P93-129 - 4TH AVENUE GARAGE

- REQUEST:
- A. Variance to allow a second floor on a detached accessory structure containing 944 square feet on 0.11± developed acres in the Standard Single Family (R-1) zone.
 - B. Variance to increase the rear yard lot coverage for a detached accessory structure from 25 to 46 percent.
 - C. Variance to reduce the maneuvering area behind a garage from 26 feet to 22 feet.
 - D. Variance to increase the maximum allowed wall height for a detached accessory structure from 10 feet to 15.5 feet.

SUMMARY/RECOMMENDATION: The applicant proposes to demolish an existing single car garage and construct a 944 square foot, two car, detached garage with a second story on 0.11± developed acres. In order to meet the applicant's objectives, the project requires the discretionary planning entitlements described above. In evaluating the project, the basic issues are the height of the structure and compatibility of design. **Staff recommends approval of the variances subject to conditions.** This recommendation is based upon existing circumstances in the alley and previous recommendations on other variances for detached structures.

EXHIBIT C-1

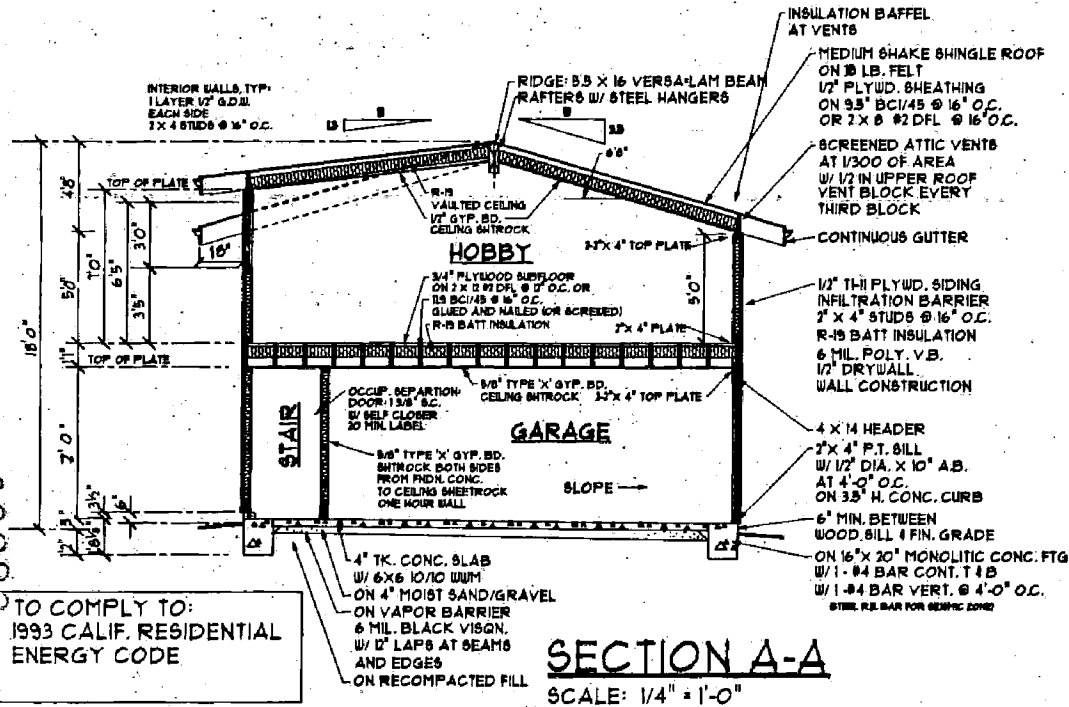
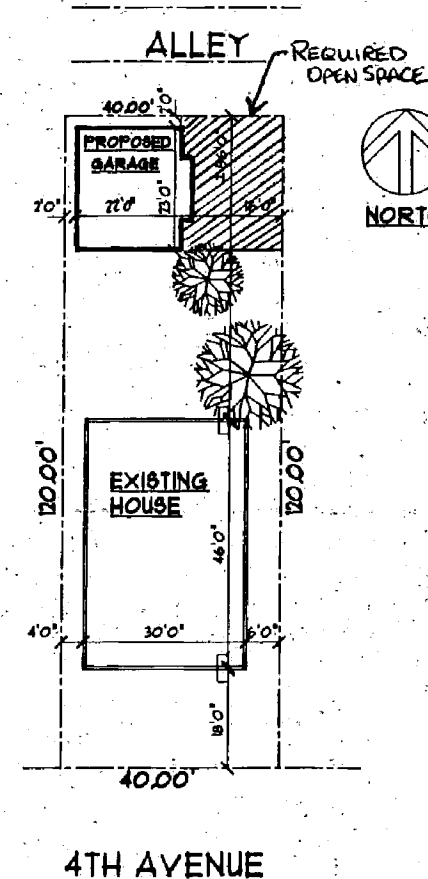
Lot Coverage: The applicant has requested a variance to exceed the maximum 25 percent rear yard lot coverage. The proposal covers 46 percent of the rear yard (last 15 feet). Meeting the 25 percent requirement would only allow a single car garage. Staff has no objection to the increase in rear yard lot coverage. There is adequate outdoor area to compensate for the loss of area within the last 15 feet. Staff suggests the applicant maintain adequate open space on the lot (see Exhibit C-1) to compensate for the loss within the last 15 feet.

- A. The site shall maintain the required open space as indicated on Exhibit C-1.
- B. The applicant shall submit revised elevations for review and approval of Planning staff prior to the issuance of Building Permits. The revised elevation shall be similar to Exhibit C-4 and include:

EXHIBIT C-4

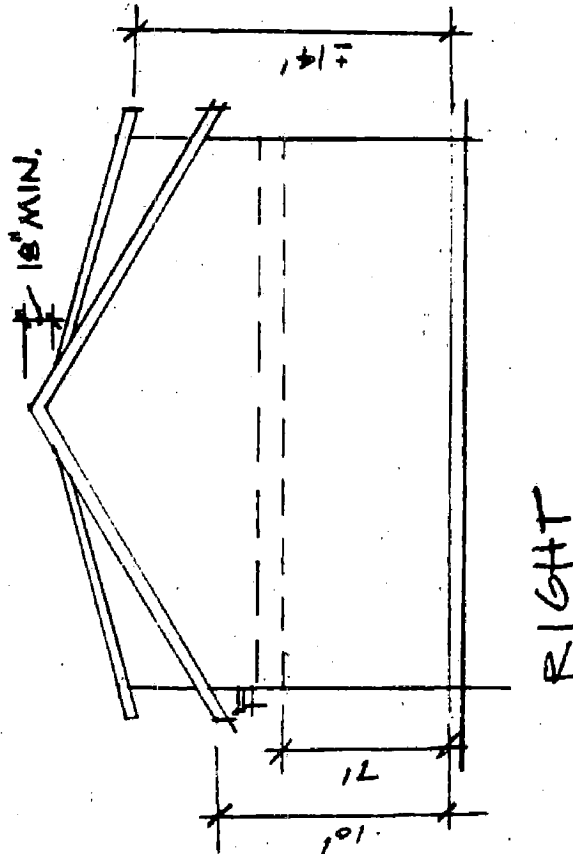
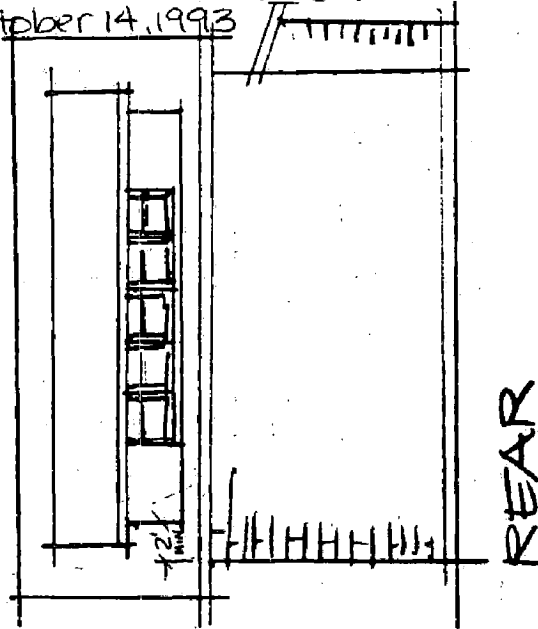
second floor is not going to be used as a living area (i.e., bedroom). It is only a hobby room for the residents of the existing single family home. Staff does object to the increased wall height as shown on the applicant's elevations. The approval of the second floor on the detached garage should only be allowed if the structure can meet the height requirements of the Zoning Ordinance. Staff has suggested the necessary ceiling height for the second floor be accomplished using dormers similar to Exhibit C-4, leaving the first plate line at the maximum 10 feet, and the second plate line of the dormers at 14 feet. The applicant proposed a dormer which covered all but 18 inches on either end of the building. The dormer should inset a minimum of two feet from the main wall. Other garages have had approved variances for second floors while not exceeding the maximum wall height. Staff recommends approval of the variance to increase the wall height and allow the second floor, provided the design be revised similar to Exhibit C-4.

The applicant is proposing to construct the detached garage using a medium shake shingle roof with T1-11 plywood siding. The existing residence has a shake roof with shingles used as the exterior material. The existing residence also has a very steep roof. The applicant's proposed design does not adequately complement the existing roof pitch of the residence. Meeting the wall height of 10 feet and maintaining the maximum height of 18 feet, will better accomplish complementing the existing design of the house. As described in the Height section, the dormer should be redesigned similar to Exhibit C-4.

- 1) the total height of the garage shall not exceed 18 feet;
 - 2) the first floor plate line a maximum of 10 feet;
 - 3) the second plate line for the dormers a maximum of 14 feet;

- 4) the top of the dormer a minimum of 18 inches below the peak of the roof;
 - 5) the dormer shall be a minimum of two feet inset from the main wall of the garage;

- 6) the exterior material shall be the T1-11 plywood siding indicated on shingle siding as exists on the residence; and
 - 7) the roof material shall be medium shake.
